TRAFFIC ENGINEERING AND OPERATIONS BULLETIN 19-03
ROADWAY DESIGN BULLETIN 19-03
PROGRAM MANAGEMENT BULLETIN 19-03
CONSTRUCTION BULLETIN 19-01

DATE: July 3, 2019

SUBJECT: **Wrong-way Driving Advanced Countermeasures at Interchange Exit Ramps**

Standard Plans Interim Revision, [Index IR700-120-01](#) (Enhanced Highway Signing Assemblies, Roadside Assembly-7)

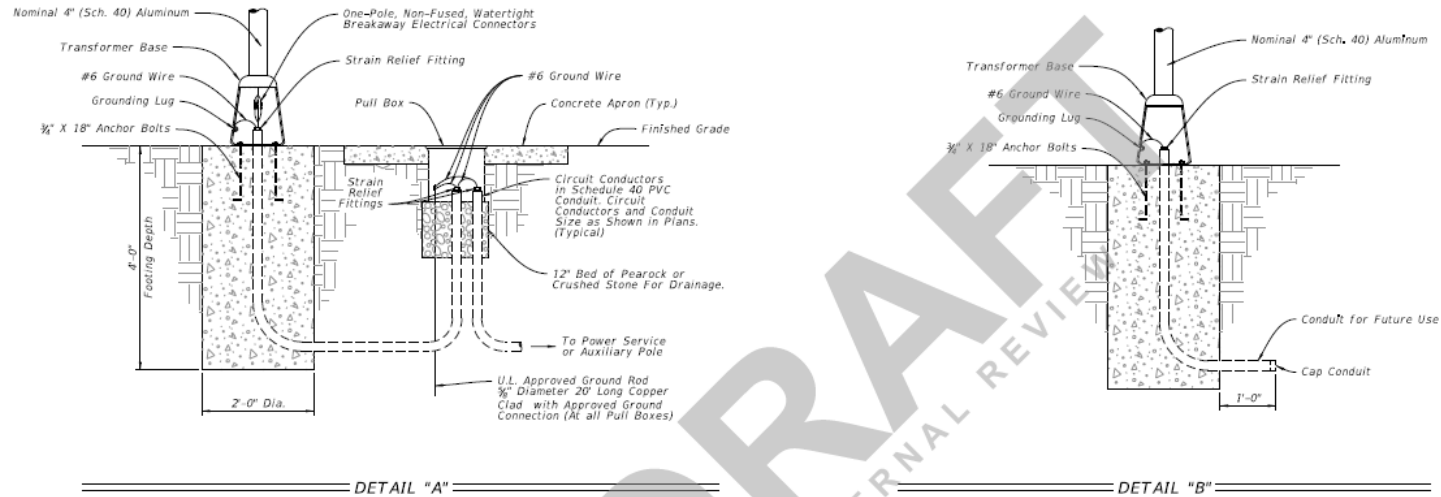
1. The following ***FY 2019-20 Standard Plans Interim Revision (IR)*** is released:

2. Sheets 1, 2, and 9 of *Index IR700-120-01* are shown in Attachment 'A'.

ROADSIDE SIGN ASSEMBLY-7				
LAST REVISION 05/ /19	DESCRIPTION: Added Roadside Sign Assembly-7	FDOT FY 2019-20 STANDARD PLANS	ENHANCED HIGHWAY SIGNING ASSEMBLIES	INDEX 700-120 SHEET 9 of 10

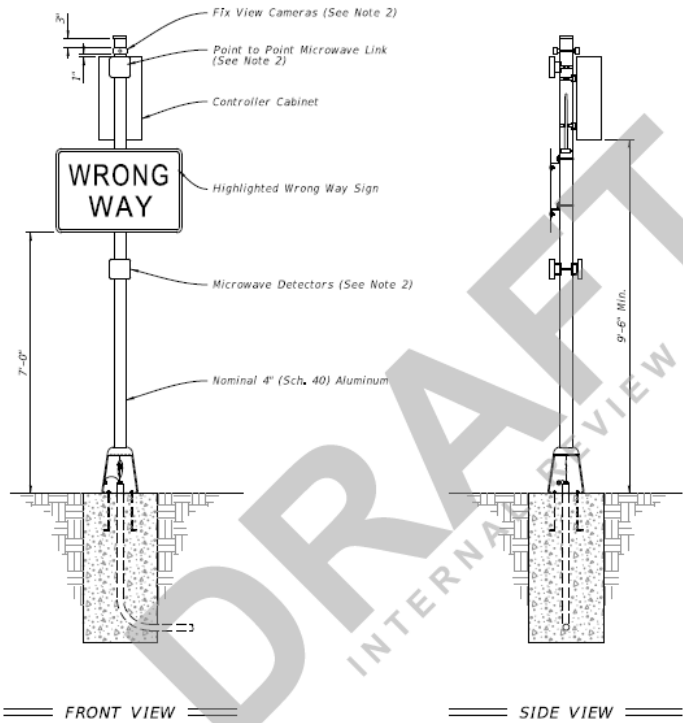
- NOTES:**
- 1. Type A7 Assembly (Conventionally-Powered) is shown. Type B7 Assemblies (Solar-Powered) Similar.
 - 2. Install cameras, point to point microwave link, microwave detectors, and antennas in accordance with the manufacturer's instructions.

ATTACHMENT ‘B’

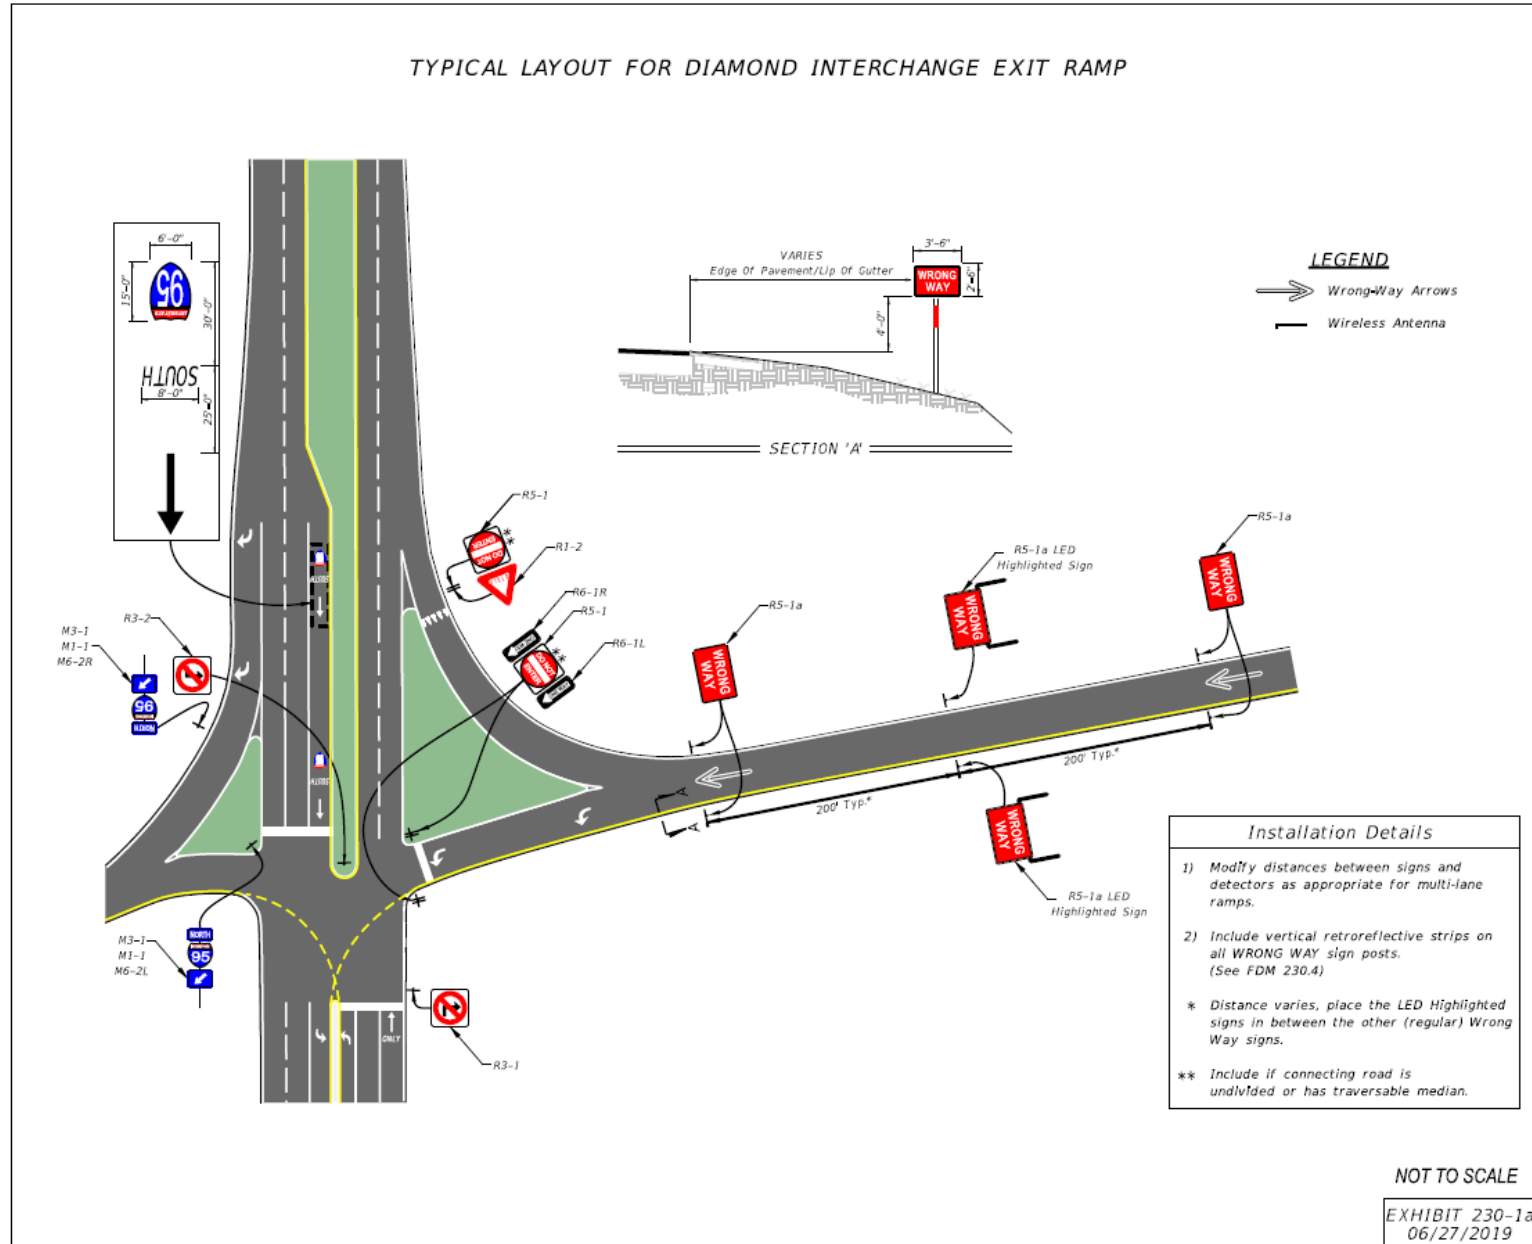
The standard for signing and pavement marking and advanced countermeasure installation at exit ramp intersections are illustrated in Exhibit 230-1a and 230-1b. The description of the layouts are as follows:

- 1) Include MUTCD “optional” signs; second DO NOT ENTER, second WRONG WAY sign, and ONE WAY signs.
- 2) Include NO RIGHT TURN and NO LEFT TURN signs.
- 3) Use 3.5 feet by 2.5 feet WRONG WAY signs mounted at four-foot height and include a retroreflective strip on sign supports.

- 4) Include 2-4 dotted guide line striping for left turns between ramps entrances/exits and cross-streets.
- 5) Include retroreflective yellow paint on ramp median nose where applicable.

- 6) Include a straight arrow and route shield pavement marking in left-turn lanes extending from the far-side ramp intersection through the near-side ramp intersection to prevent premature left turns. Refer to TEM, Section 4.2.4 “Route Shields for Wrong Way Treatment” for additional information.

- 7) Include a straight arrow and ONLY pavement message in outside lane approaching the ramp exit.
- 8) Install a pair of Light-emitting Diode (LED) Highlighted Wrong-Way Signs. For long ramps or for ramps with limited sight distance, two sets of the pairs of Highlighted Signs may be used, as illustrated in ***Exhibits 230-1a*** and ***230-1b***. The Highlighted Sign assembly may be powered by either solar or line power. If line power is used, include the power service assembly and conduit and cable from the Highlighted Sign to the service point. The Highlighted Sign shall be integrated back to the District’s Traffic Management Center (TMC). Connectivity between the Highlighted Sign and the TMC may be provided by either fiber optic or wireless communications. If fiber optic communications are used, include the fiber optic cable, conduit, and transmission equipment. If wireless communications are used, include the antenna and transmission equipment.

2. Replace ***FDM Exhibit 230-1*** with the corresponding exhibits in Attachment ‘B’.

Figure 7.2.1 Typical Layout for Diamond Interchange Exit Ramp

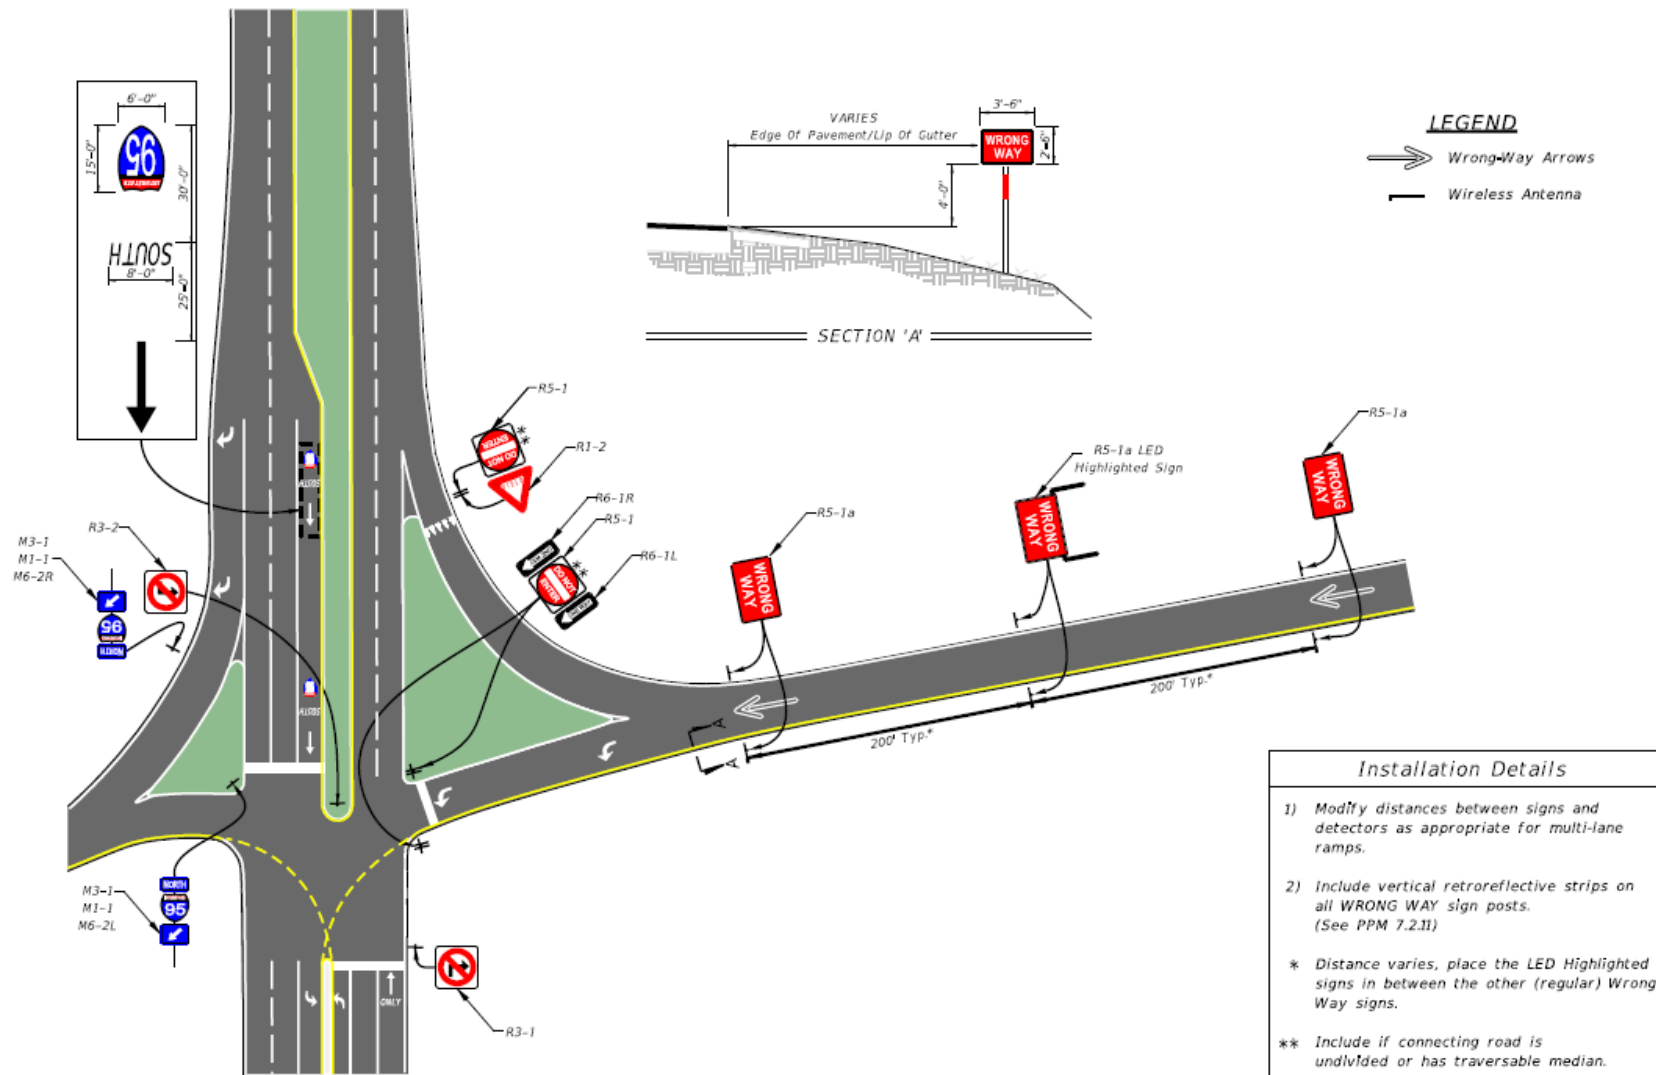
The standard for signing and pavement marking and advanced countermeasure installation at exit ramp intersections are illustrated in Figures 7.2.1 and 7.2.2. The description of the layouts are as follows:

- 1) Include MUTCD “optional” signs; second DO NOT ENTER, second WRONG WAY sign, and ONE WAY signs.
- 2) Include NO RIGHT TURN and NO LEFT TURN signs.
- 3) Use 3.5 feet by 2.5 feet WRONG WAY signs mounted at four-foot height and include a retroreflective strip on sign supports.

- 4) Include 2-4 dotted guide line striping for left turns between ramps entrances/exits and cross-streets.
- 5) Include retroreflective yellow paint on ramp median nose where applicable.

- 6) Include a straight arrow and interstate shield pavement marking in left-turn lanes extending from the far-side ramp intersection through the near-side ramp intersection to prevent premature left turns. Refer to TEM, Section 4.2.4 “Route Shields for Wrong Way Treatment” for additional information.

- 7) Include a straight arrow and ONLY pavement message in outside lane approaching the ramp exit.
- 8) Install a pair of Light-emitting Diode (LED) Highlighted Wrong-Way Signs. For long ramps or for ramps with limited sight distance, two sets of the pairs of Highlighted Signs may be used, as illustrated in ***Figures 7.2.1*** and ***7.2.2***. The Highlighted Sign assembly may be powered by either solar or line power. If line power is used, include the power service assembly and conduit and cable from the Highlighted Sign to the service point. The Highlighted Sign shall be integrated back to the District’s Traffic Management Center (TMC). Connectivity between the Highlighted Sign and the TMC may be provided by either fiber optic or wireless communications. If fiber optic communications are used, include the fiber optic cable, conduit, and transmission equipment. If wireless communications are used, include the antenna and transmission equipment.

2. Replace ***PPM Figures 7.2.1*** and ***7.2.2*** with the corresponding figures in Attachment ‘C’.
